CONTRACT ADDENDUM

GLYNN ARCHER DRIVE/ 14TH STREET ROADWAY RECONSTRUCTION FROM NORTH ROOSEVELT BLVD. TO FLAGLER AVENUE

Project No. EN-1004
(Lap Agreement FM #420042-1)

Addendum No. 3

CROSS SECTIONS
 SHEET NO. 31

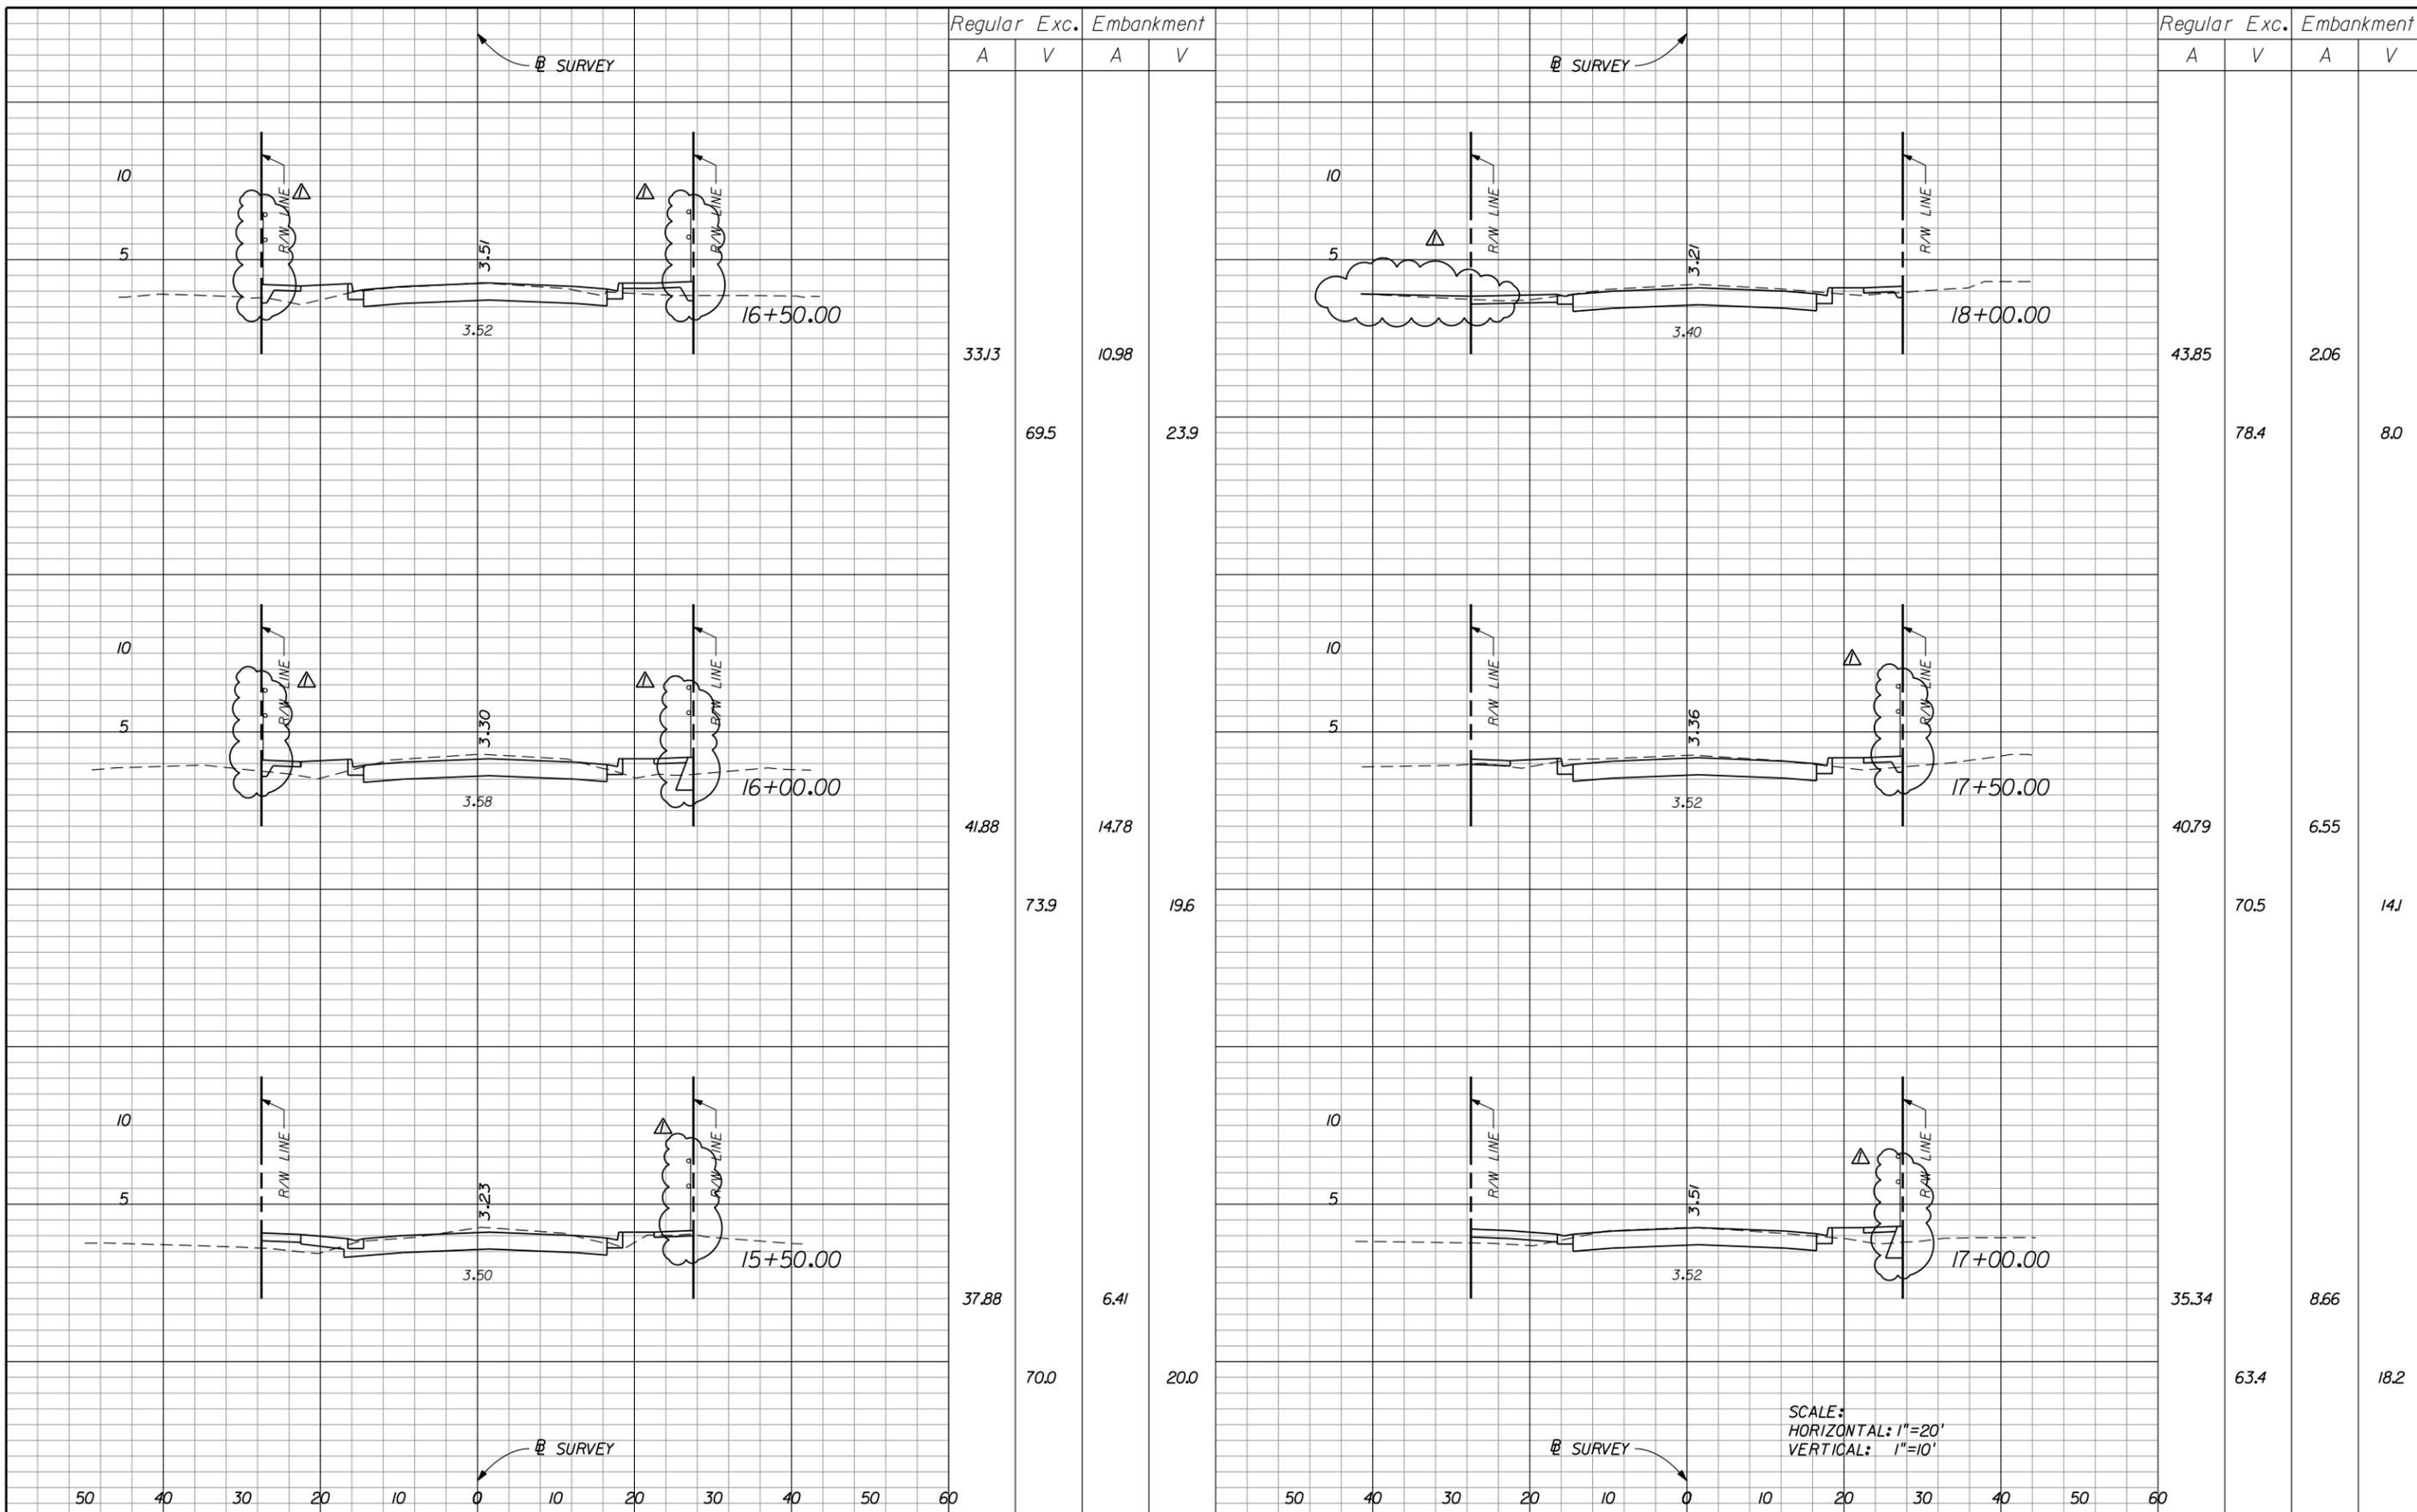
REVISIONS			
DATE	DESCRIPTION	DATE	DESCRIPTION
02-29-12	CEV Δ MODIFIED CROSS SECTIONS

CROSS SECTIONS
 SHEET NO.: 32

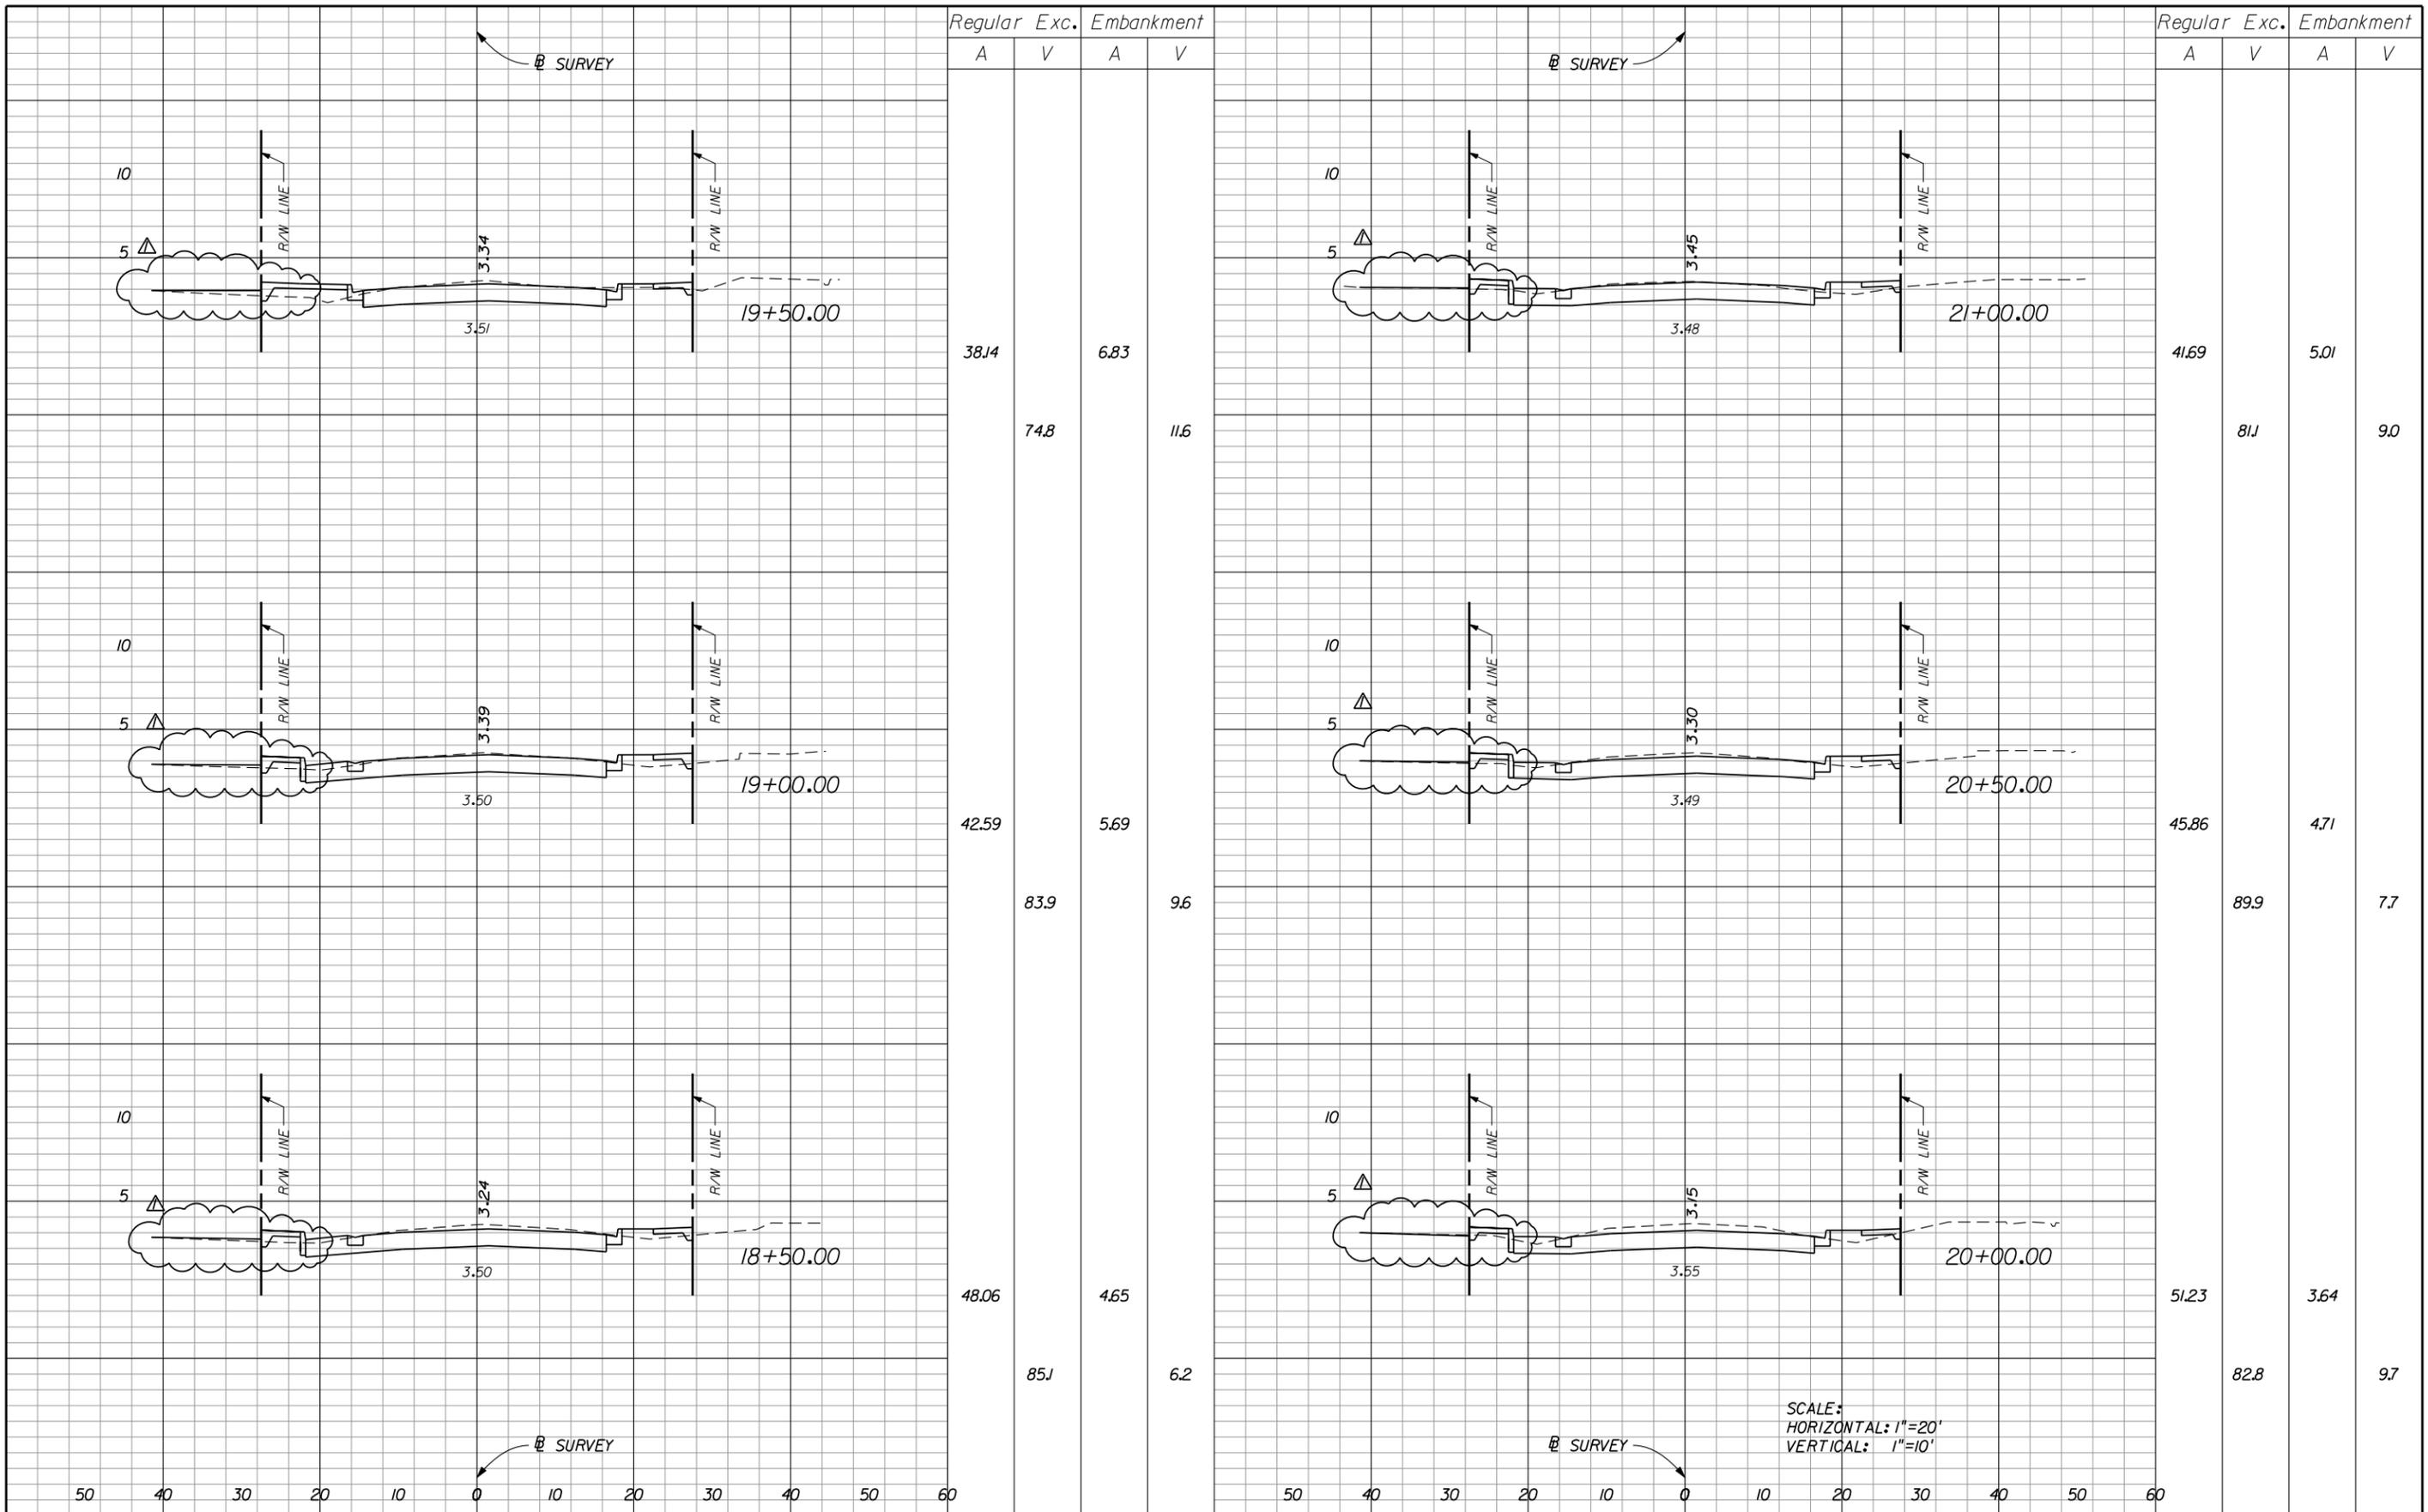
REVISIONS	
DATE	DESCRIPTION
02-29-12	CEV Δ MODIFIED CROSS SECTIONS

SHEET NO.
33

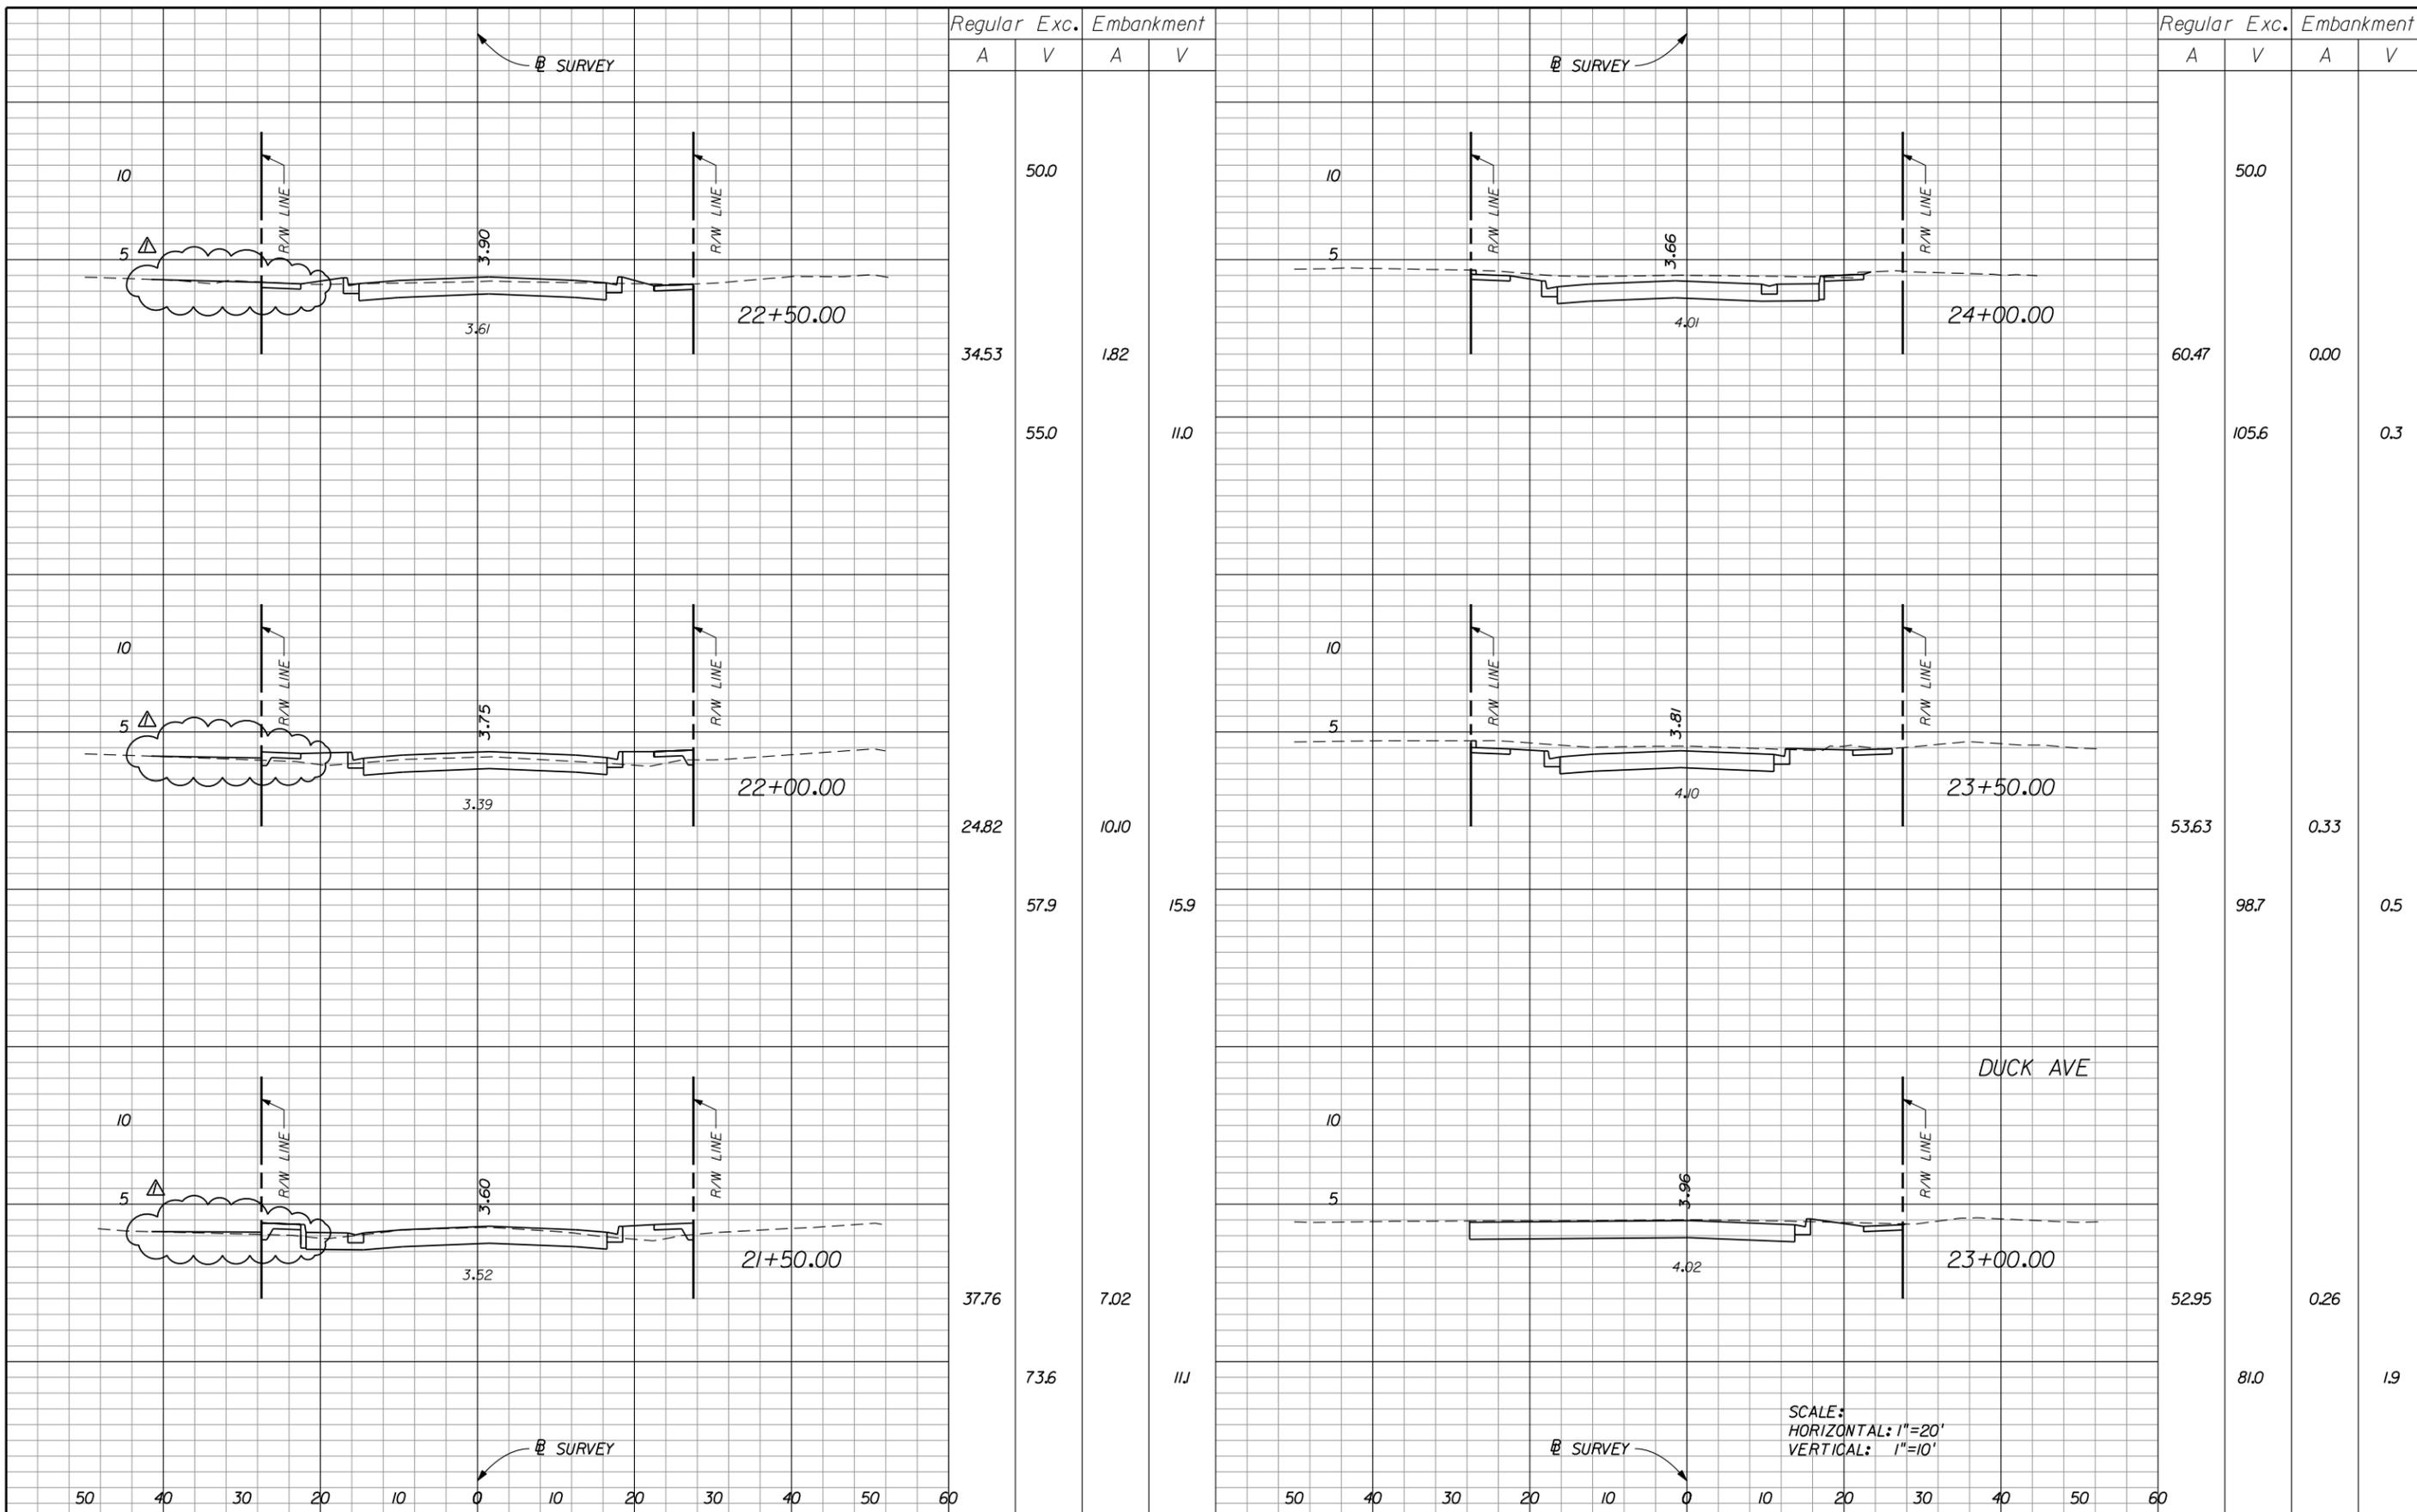
REVISIONS			
DATE	DESCRIPTION	DATE	DESCRIPTION
02-29-12	CEV Δ MODIFIED CROSS SECTIONS
